February 22, 2016

Minimum Security Prison – Metal Roof Recovery
4800 Community Ave.
McKinney, Texas 75071

ADDENDUM NUMBER ONE

Skylight and/or Equipment Curb Extension Detail

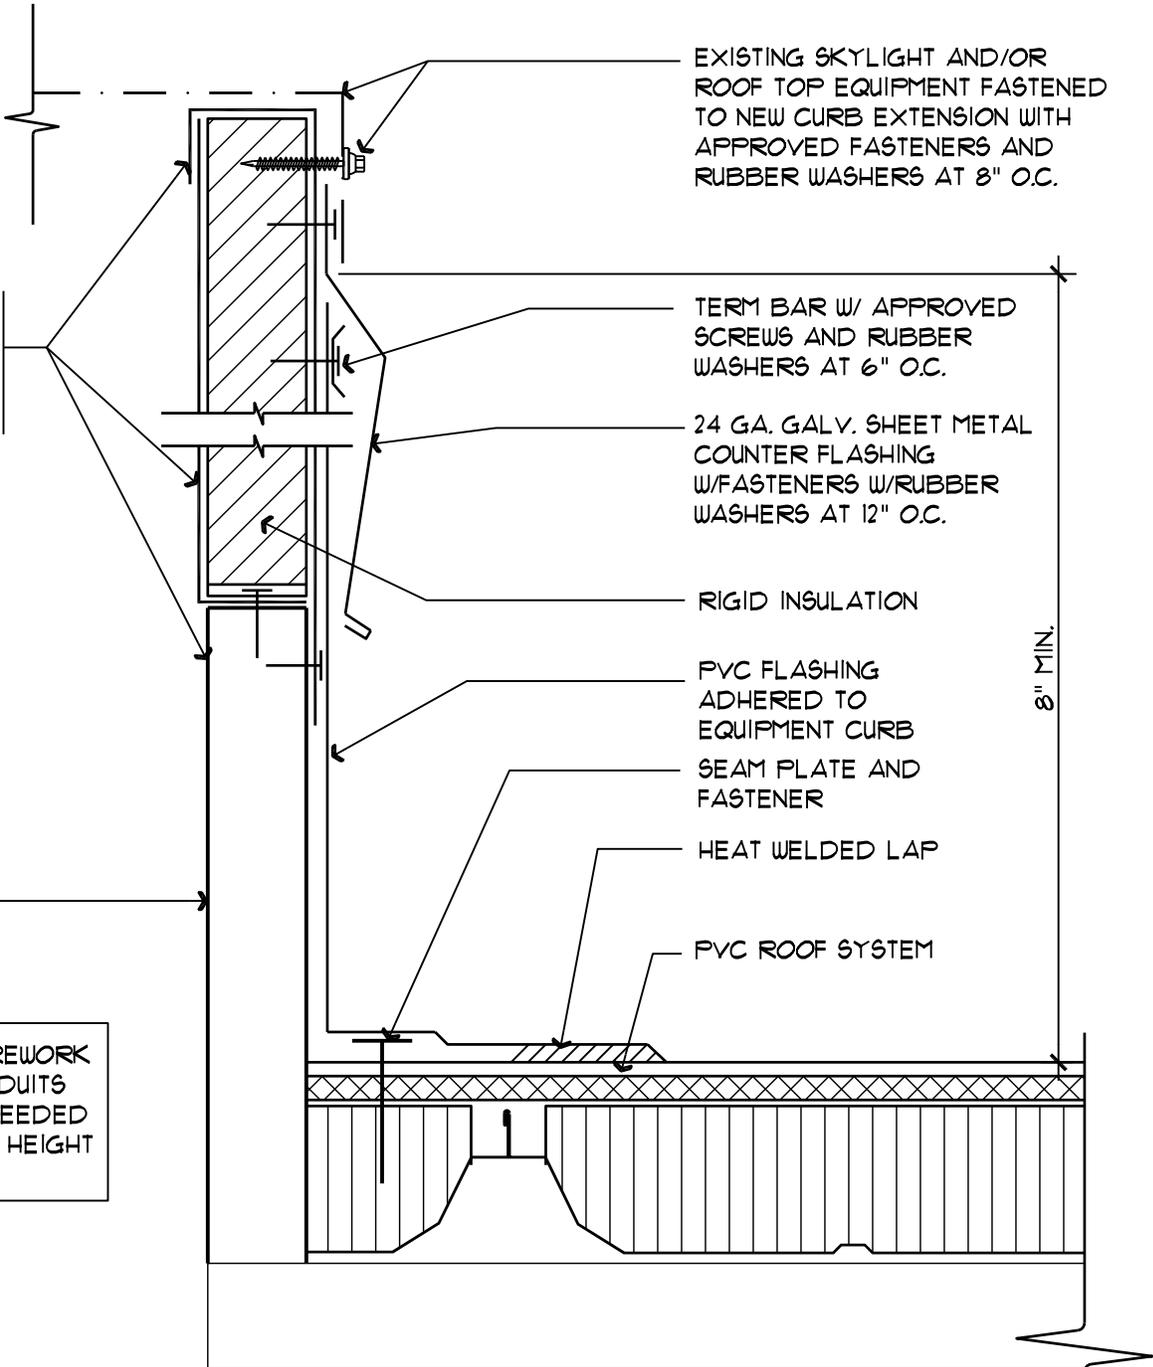
5. Construction work will be allowed from 7:00 a.m. to dark., including weekends.
6. Work can be performed Monday thru Sunday.
7. All skylight and equipment curbs shall be raised to provide for eight inch minimum flashing heights from top of the highest adjacent roof level. Refer to the attached Sheet SK-1 dated 2/22/16 for curb extension detail.

EXTEND EXISTING SKYLIGHT OR EQUIPMENT CURB USING SAME GAUGE AND TYPE OF SHEET METAL AS THE EXISTING CURB THAT IS TO REMAIN

NOTE: WHERE REQUIRED, REWORK EXISTING ELECTRICAL CONDUITS AND ASSOCIATED WIRING NEEDED AS A RESULT OF THE CURB HEIGHT EXTENSION.
